RE: Phase II Athletics – Baseball/Softball Fields - Change Order 02 – Bullitt Central Site Revisions **DC**

Change Order

PROJECT: *(Name and address)*
BCPS - Phase II Athletics - Bid Package
No. 1 - Baseball and Softball
Bullitt County, Kentucky

CHANGE ORDER INFORMATION:
Change Order Number: 002

2023-50
C1.23
BCHS

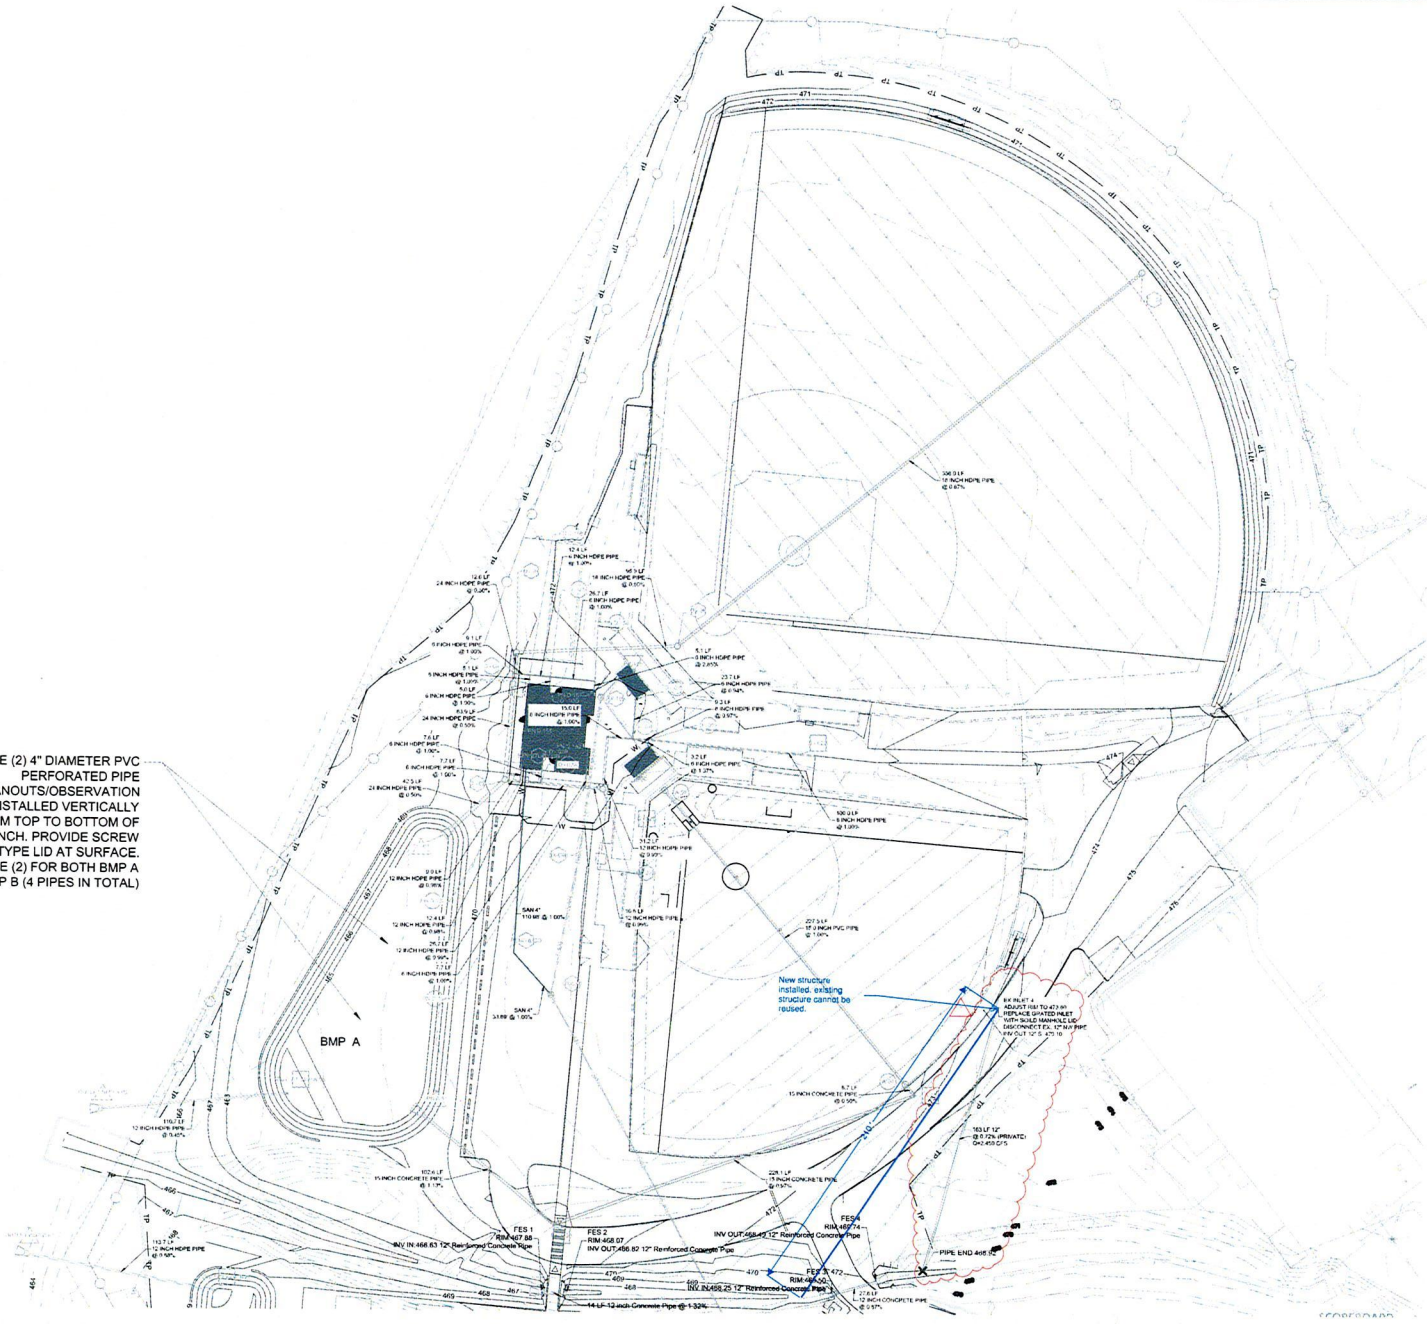
Additional 12" storm pipe per RFI 3 response. Route of pipe has been adjusted to avoid additional tree clearing and moving Clahoun jobsite trailer.

C1.12
BCHS

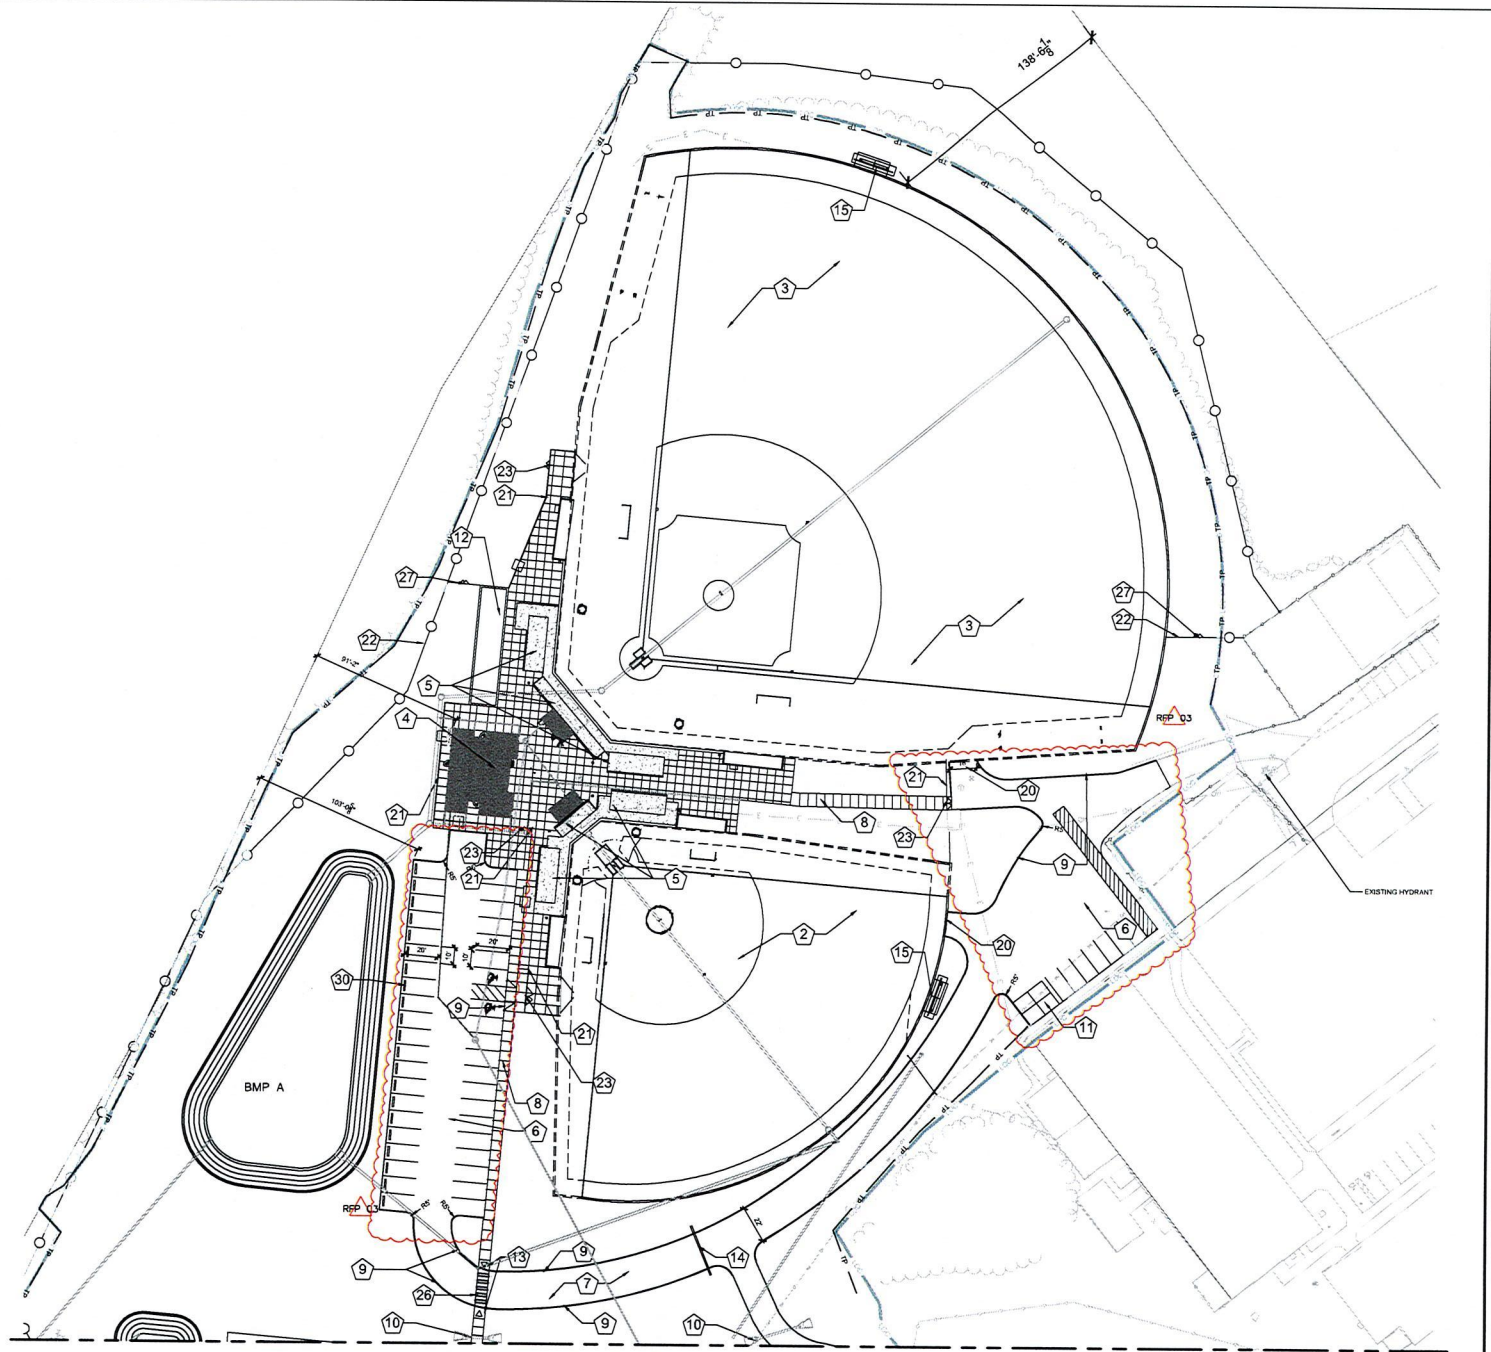
- demo headwall and 18" hdpe pipe
 - add sawcut line for parking lot improvements
- C1.12 BCHS LAYOUT PLAN
 - adjust ambulance entrance to baseball field

- add parking stripping in old parking lot area
 - adjust sod hatch
 - adjust parking lot size – stalls were not correct size
- C0.03 BCHS EPSC PLAN
 - adjust loc and siltation fence

**C1.21
BCHS**

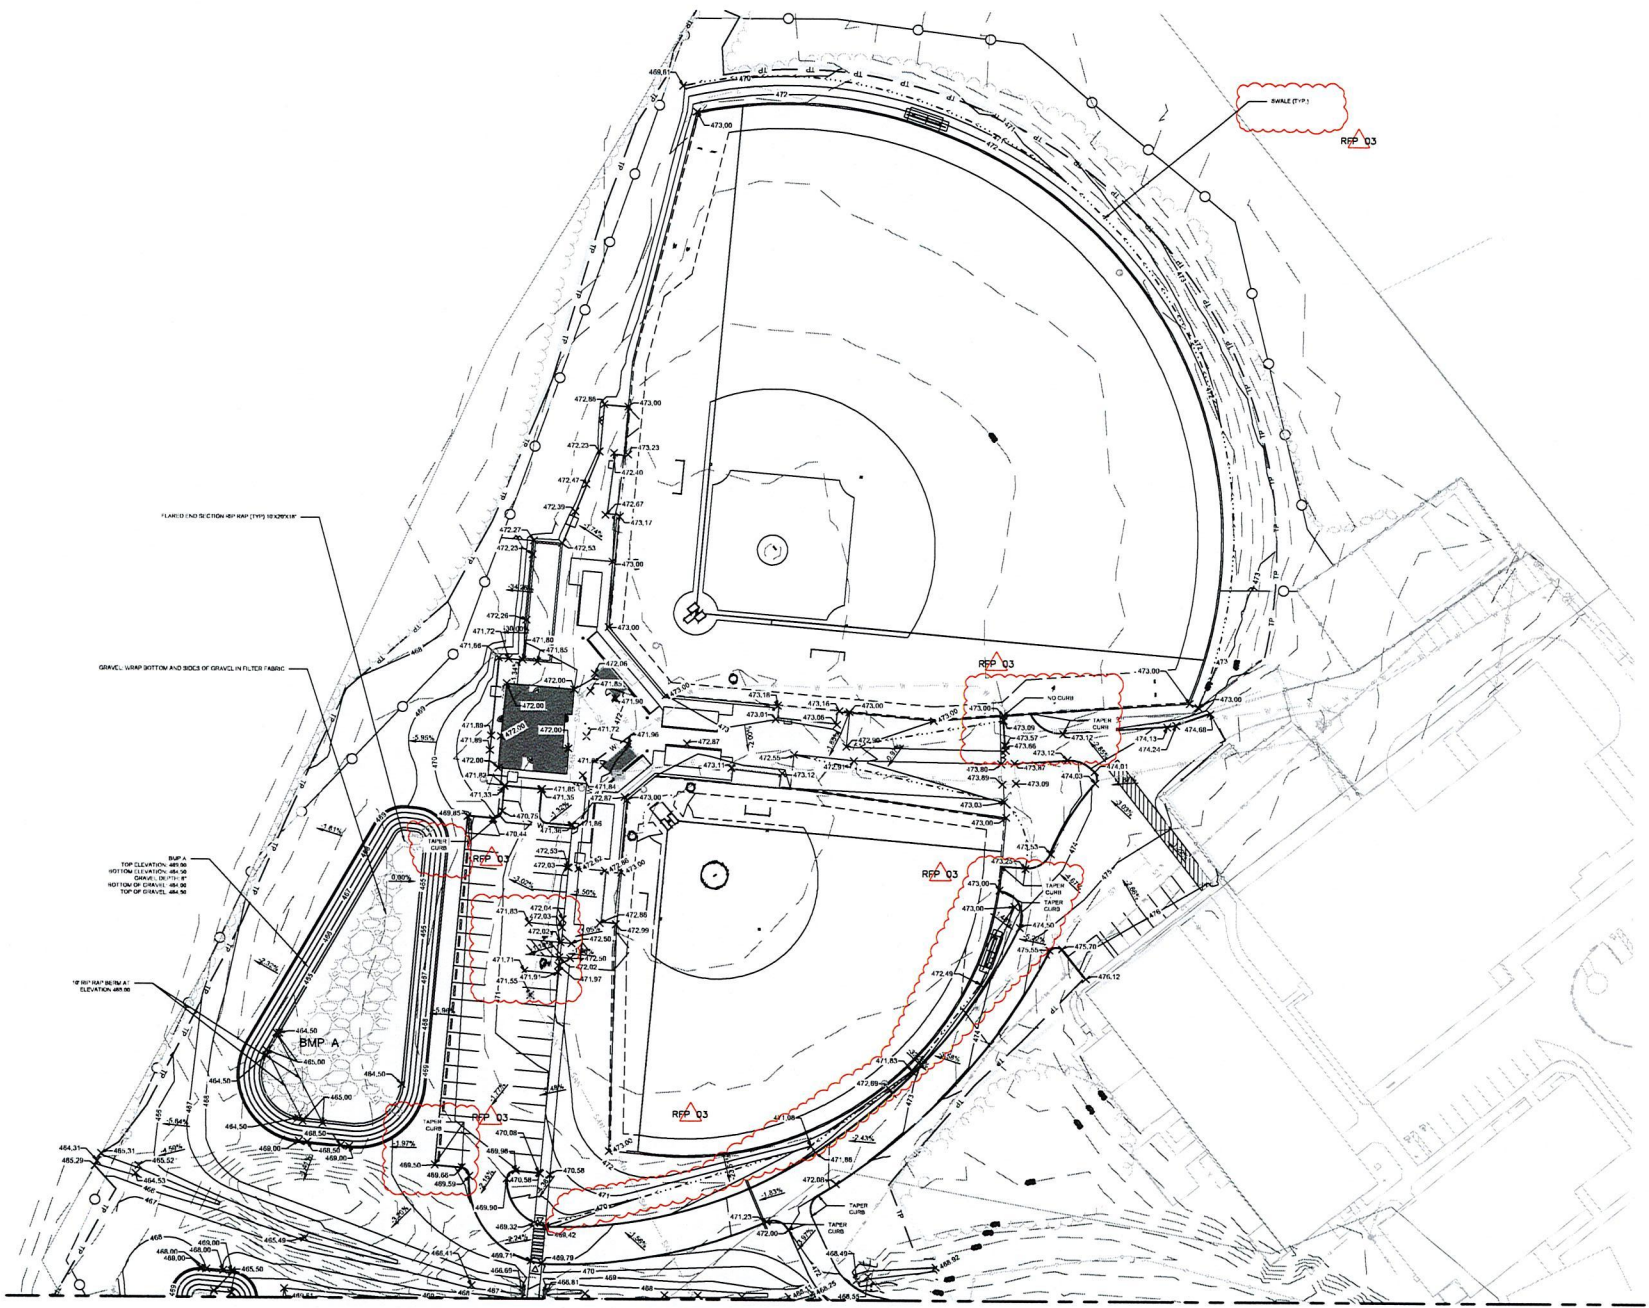
- C1.20 BCHS GRADING PLAN
 - show headwall grading from 2012 survey
 - update grading for new parking lot size and roadway tie ins
- C1.21 BCHS GRADING PLAN

- create swale between road and the south of the baseball field
 - adjust elevation points at sidewalk crossing the road
 - update grading with annotations for both ambulance entrances

- create swale along the north east from the edge of baseball field to elevation 469.61
 - pull the swale dividing the site within the limits of the property

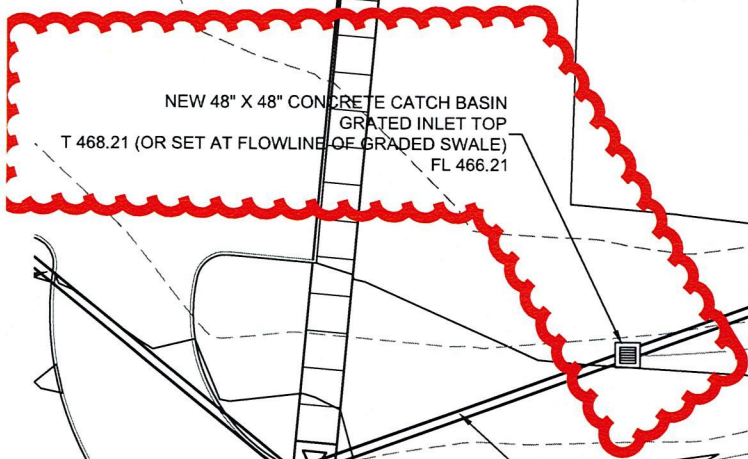
JR Notes:
 The storm structure cannot be built with the rim and invert elevations shown on the drawing. JR has priced a structure that will fit the existing 15" pipe with a rim elevation of approx. 469.04

- Item No.1** Drawing C1.21 - Parking Lot Elevations returned to Bid Documentation - Swale at Softball Field Revised
- Item No.2** ESI - New Catch Basin Exhibit
- Price Option 1: Price a 48" square catch basin as documented on the attached Exhibit.
- Price Option 2: Price for 24" square catch basin in lieu of 48" square. Provided precast basin manufacturer can accommodate 15" pipe.
- Item No. 3** Confirmation: New Sewage Ejector Pump at Concession Building can be omitted including electrical.
- Updated Electrical and Plumbing Drawings to be provided. Provide Cost Credit for this omitted work.

NEW 48" X 48" CONCRETE CATCH BASIN
GRADED INLET TOP
T 468.21 (OR SET AT FLOWLINE OF GRADED SWALE)
FL 466.21
